2026-10-01_Ottumwa-Wapello County Landfill - 90-SDP-01-75P - DNR Comment Letter Response

In correspondence dated September 4, 2026 (Doc #118045), the Iowa Department of Natural Resources commented on the 2025 Leachate Control System Performance Evaluation Report, submitted as an appendix to the 2025 Annual Water Quality Report for the West municipal solid waste landfill unit (West MSWLF unit) at the Ottumwa-Wapello County Landfill, submitted on February 26, 2026 (Doc #116265). The comments are below in italics followed by the response.

LPZ-18 Historical Leachate Column Thickness

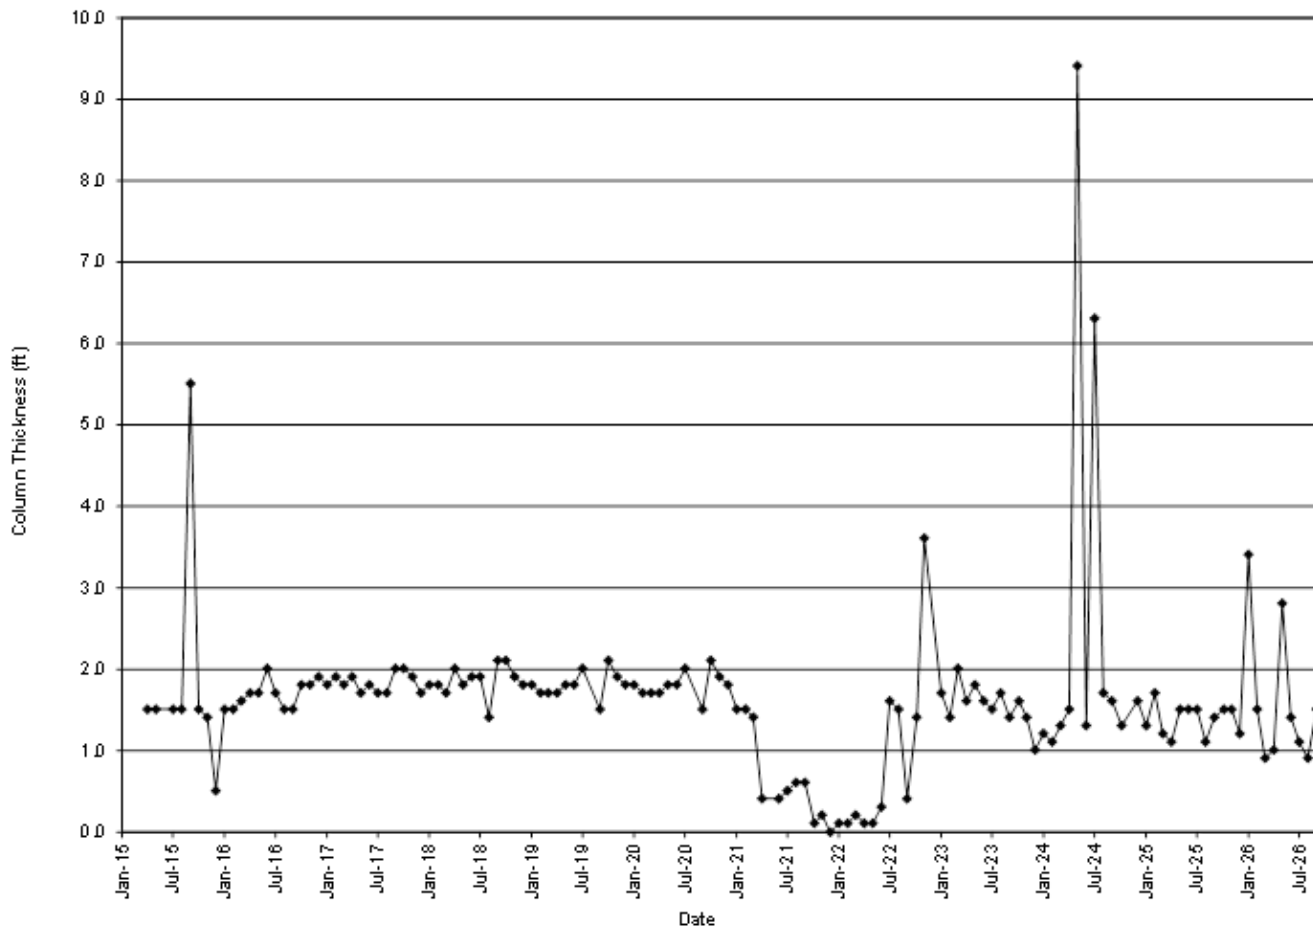
More than 1 ft leachate thickness in LPZ-18 was observed. Please provide response by October 9, 2026.

Leachate piezometer LPZ-18 was installed in March 2015 (Doc #83104). Since installation, leachate thickness measurements have been generally steady near or below 2 feet, with 5 spikes measuring greater than 3 feet thickness. The spikes were followed by a return to more typical levels at or below 2 feet. Three measurements in 2026 were at or below 1 foot of thickness. A graph of the leachate thicknesses for LPZ-18 from April 2015 through September 2026 is below. Due to the steady to generally declining leachate thicknesses at LPZ-18, it is requested that monthly monitoring continue with no further action required.
